3028624-LU

12727 30th Ave NE

Recommendation Design Guidance Meeting

Meeting Date: March 30, 2019

PARTIAL GROUND FLOOR PLAN

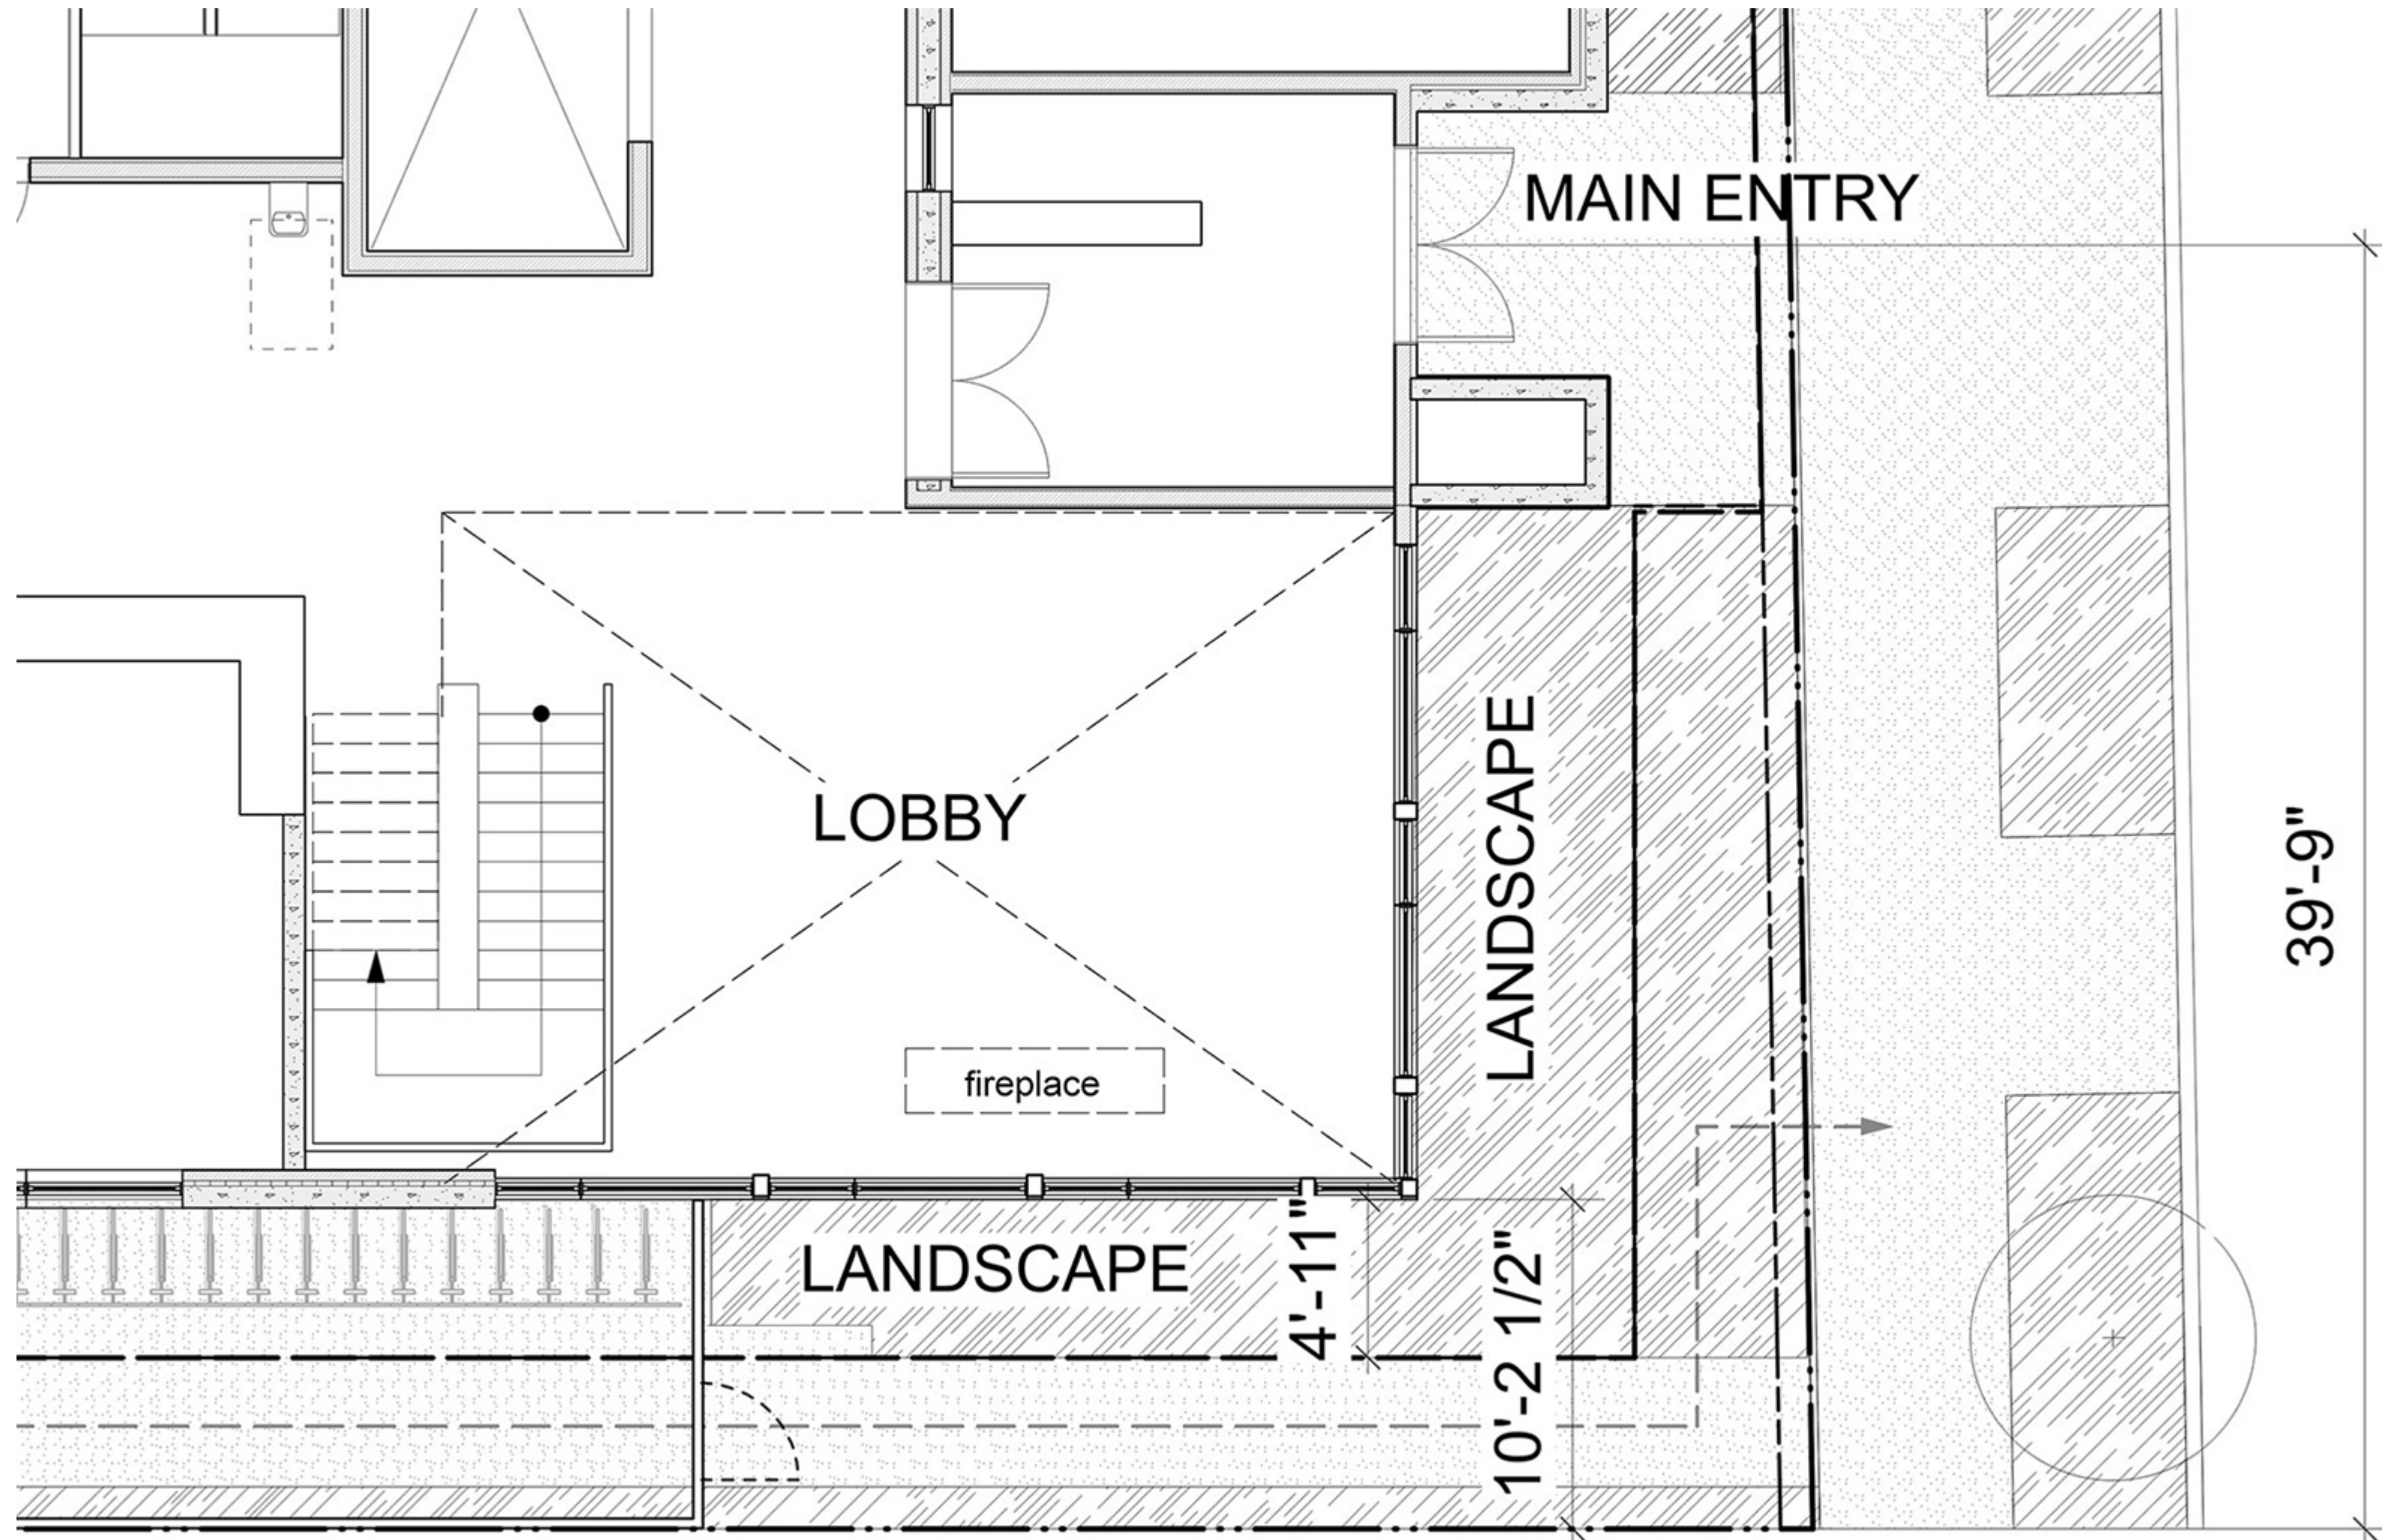
The board recommended a thoughtful design approach to the street frontage improvements and activating the street with this proposed project. The board also asked the design team to review proposed improvements for this block by SDOT and any City Light easements attached to this or the adjacent property that might be affected by this development.

- No easements will be impacted by this development
- SDOT currently has no plans for this block
- 2-story glass lobby set back from the sidewalk by a lush landscaped area
- Black metal canopy with a warm wood soffit hung from a series of textured stained concrete pilasters
- Glass overhead doors into residential activity room
- Short-term bicycle parking located in the ROW.
- Street facing façade recessed from sidewalk to provide generous pedestrian area with café style seating
- 2-stories of common spaces provide light and eyes on the street

MODEL VIEW FROM SOUTHEAST

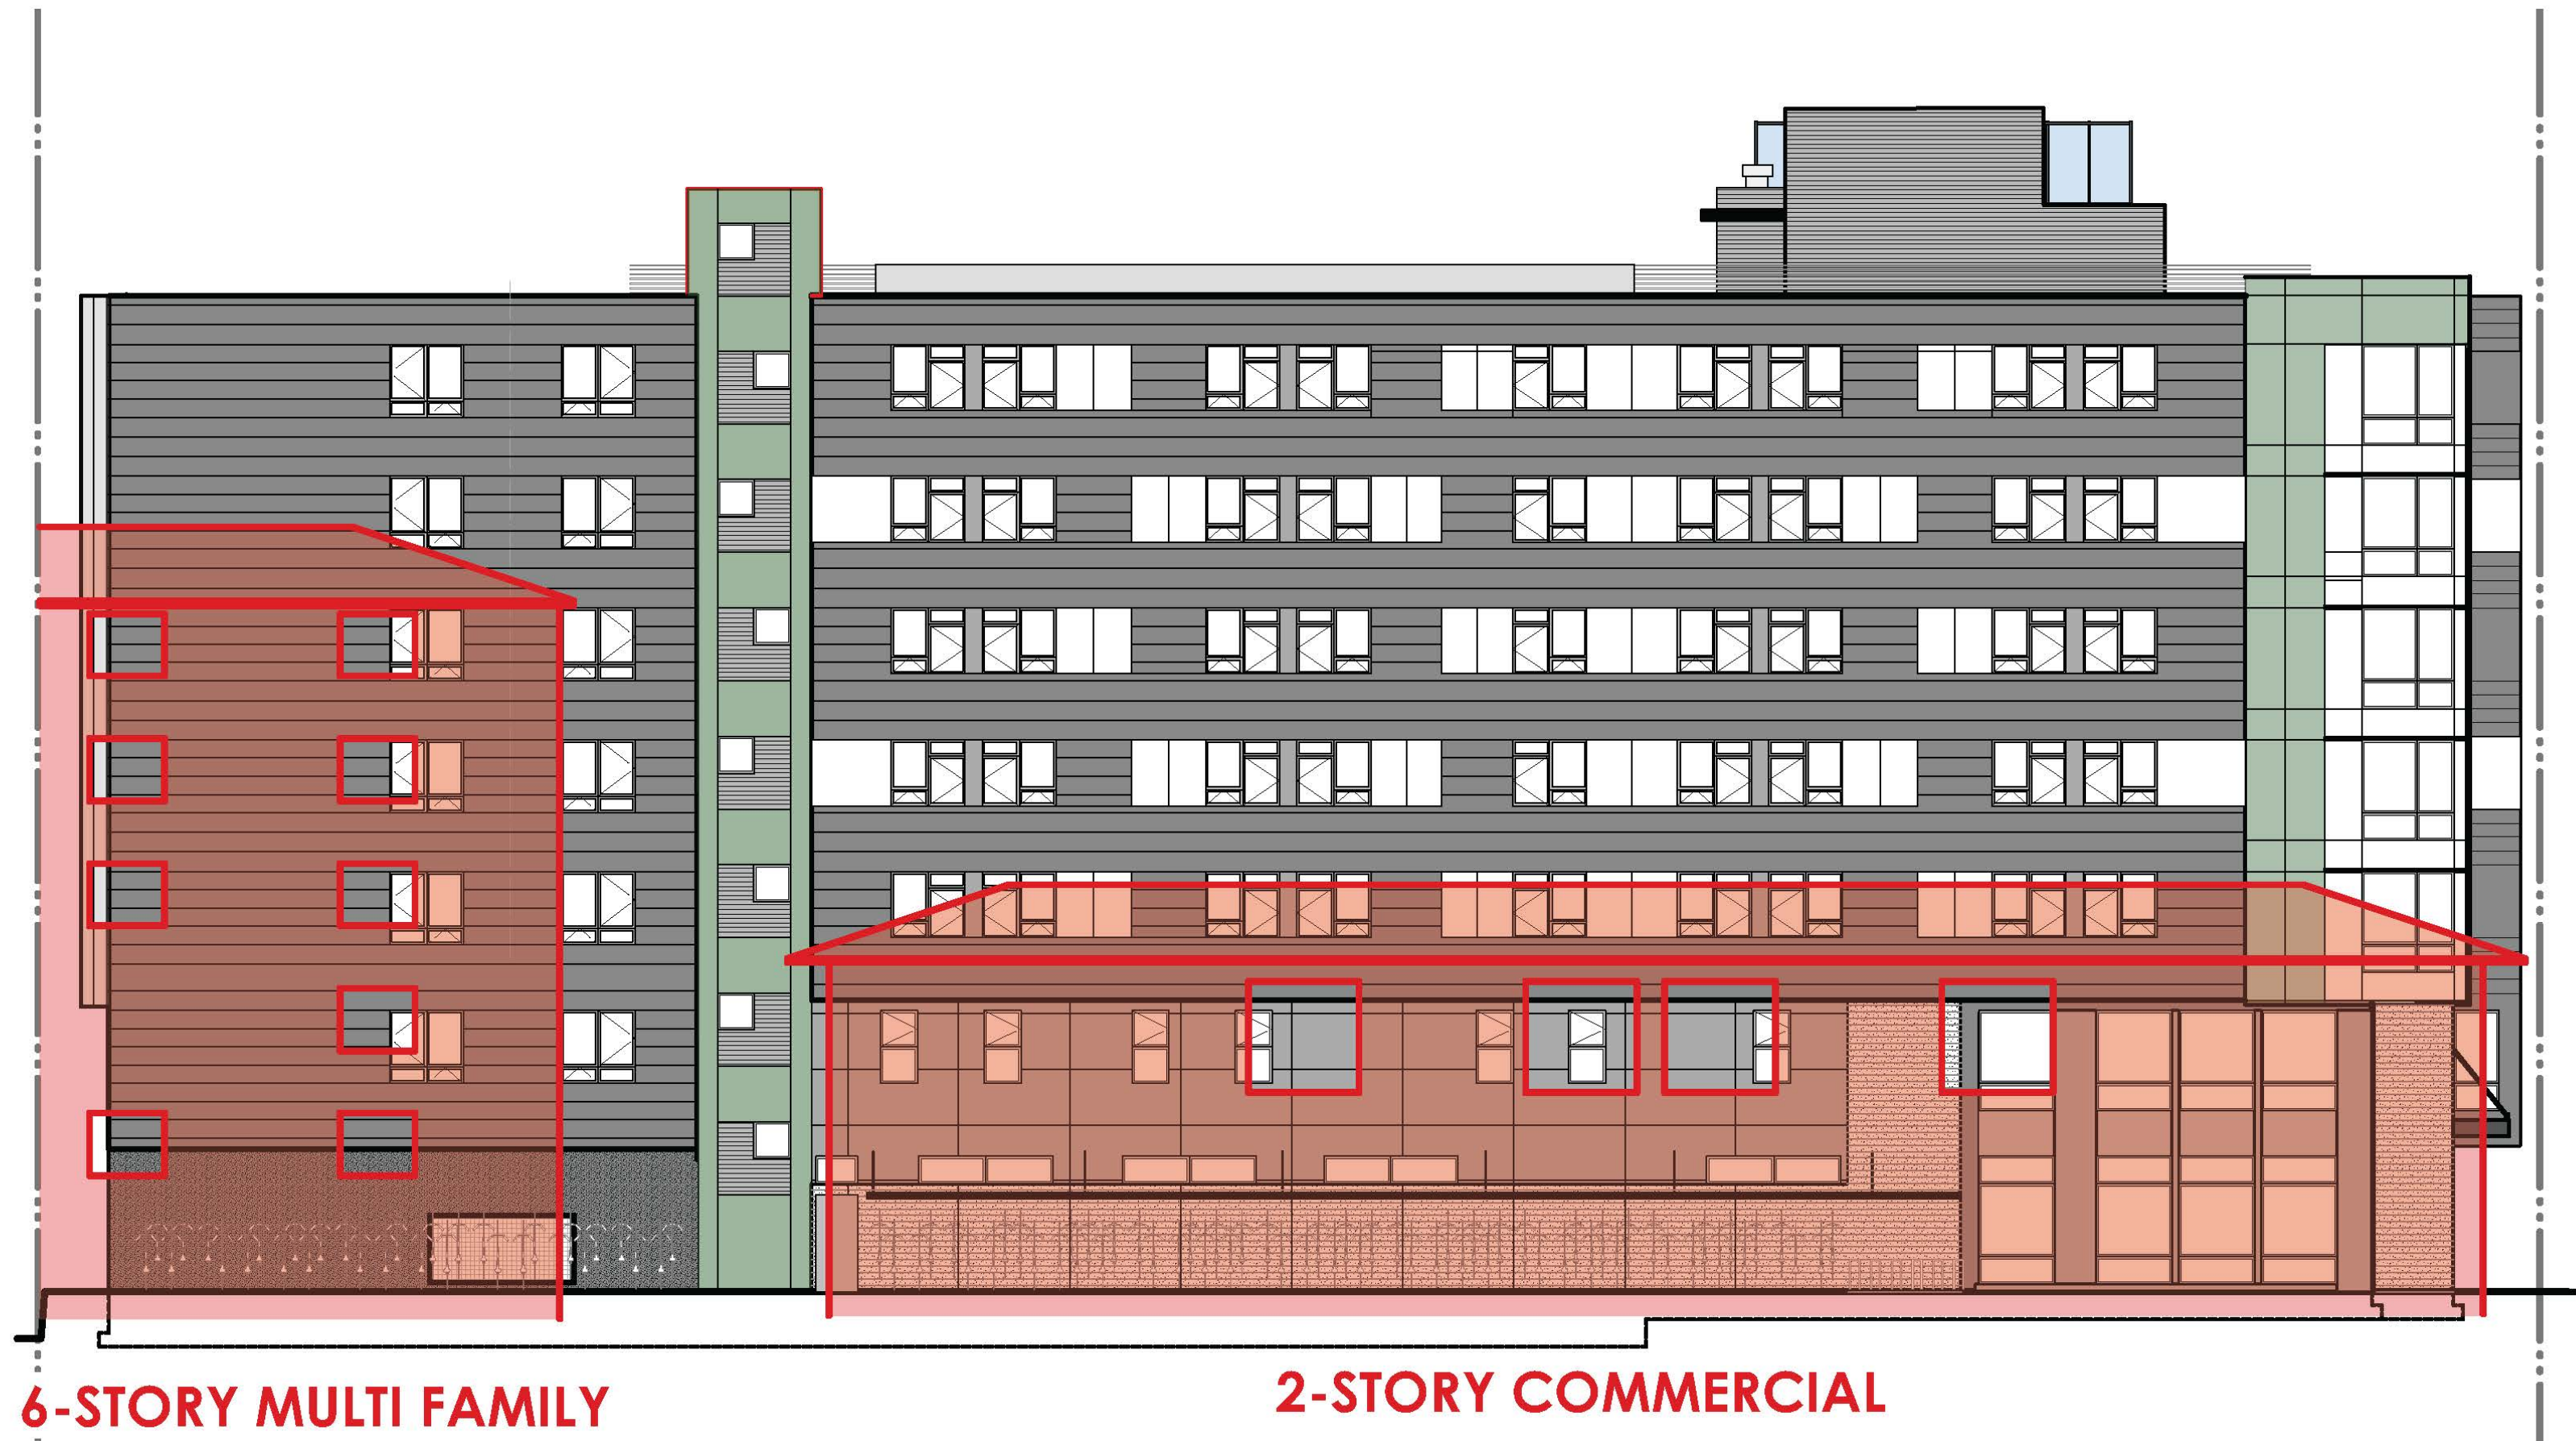
The board is concerned that the south neighbors storage of solid waste containers in the public right of way will negatively impact the this projects main entry. Suggests coordinate placement with adjacent buildings.

- Per code, the storage of solid waste is not allowed in the right of way. Presumably, the installation of new sidewalk, curb and planting strip will encourage the relocation of the south property's dumpster storage location.
- Proposed main building entry is 39'-9" from the southeast corner of the property.
- Lobby windows are pulled back 10' from the south property line to allow for landscaping that will mitigate the visual impact of the south neighbor's dumpsters.
- A gas fireplace is planned for the south side of the lobby which will further obstruct the view of the neighboring dumpsters.
- Solid waste storage for the proposed building is indoors with curbside pickup at the northeast.
